PENNSYLVANIA ELECTRIC COMPANY  
THREE MILE ISLAND NUCLEAR STATION UNIT 1

Operating License No. DPR-50  
Docket No. 50-289  
Technical Specification Change Request No. 44

Technical Specification Change Request No. 44

FIGURE 3  
(REV. 2)

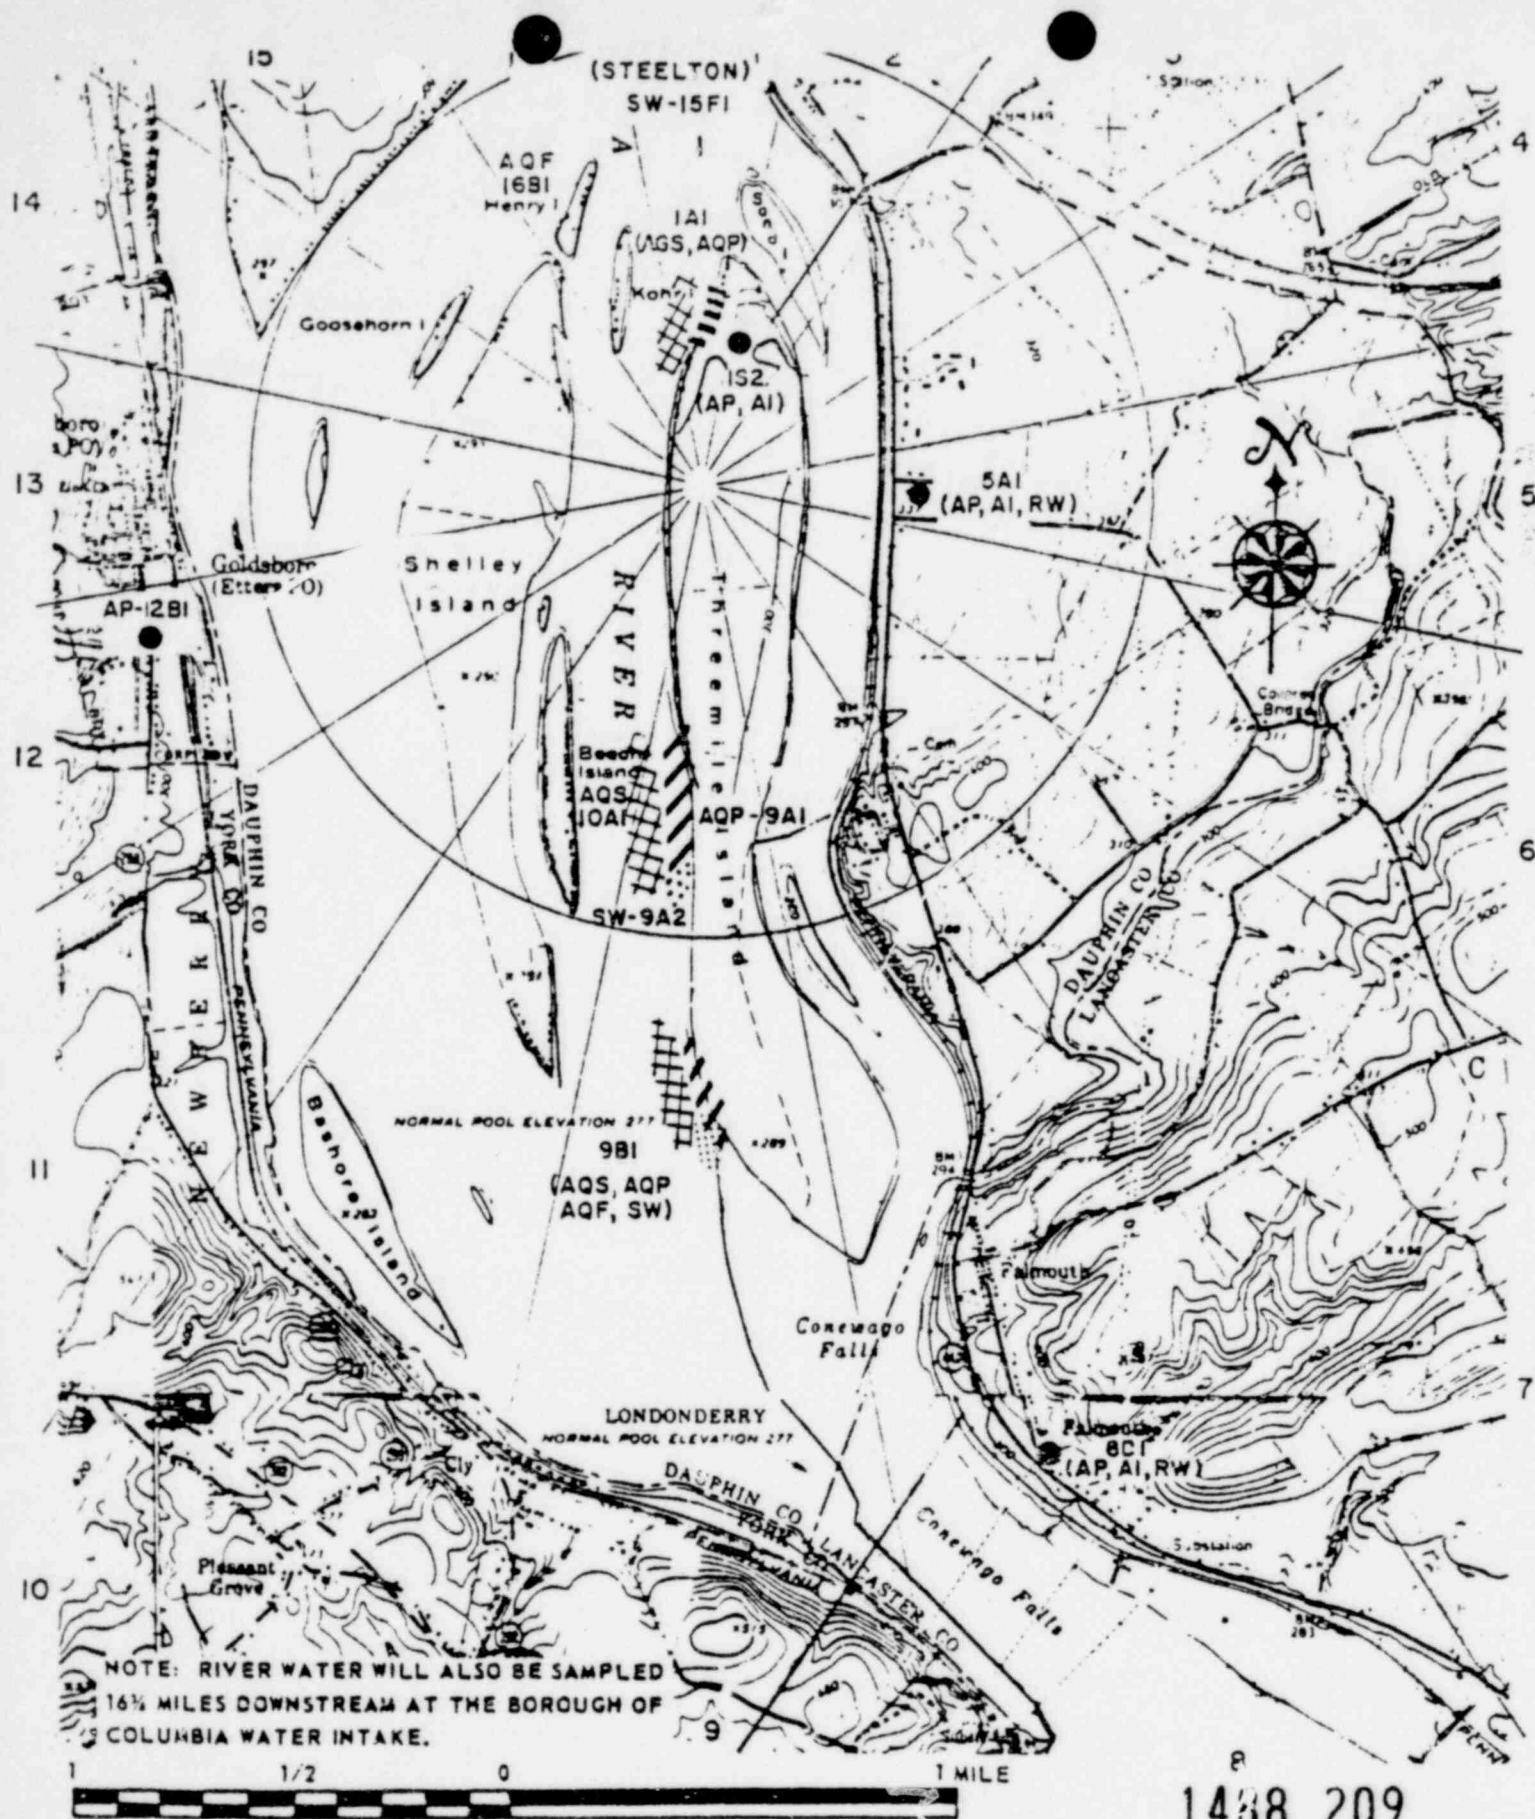
The licensee requests that the attached revised figures replace Figures 3 and 5 of the exist , Technical Specifications, Appendix B.

Legal problems have prevented Met-Ed from obtaining permission to install an air sampler at the south end of Three Mile Island (TMI) in accordance with our Technical Specification Change Request No. 16 and approved by Amendment 18 to the subject specifications. Therefore, it is requested that the sampler location now known as 9S1 on Figures 3 and 5 of the Technical Specifications, Appendix B, be replaced by a new location designated as 9C1 in the Falmouth community. A sampling station on this location was recommended by the NRC on the draft supplement to the TMI-2 Final Environmental Impact Statement (NUREG-0066), page 6-9 as part of the unit's preoperational monitoring program. The proposed location is in a low traffic area on ground controlled by Met-Ed. The sampler will be located approximately 2.2 miles ESE of the containment near a population center.
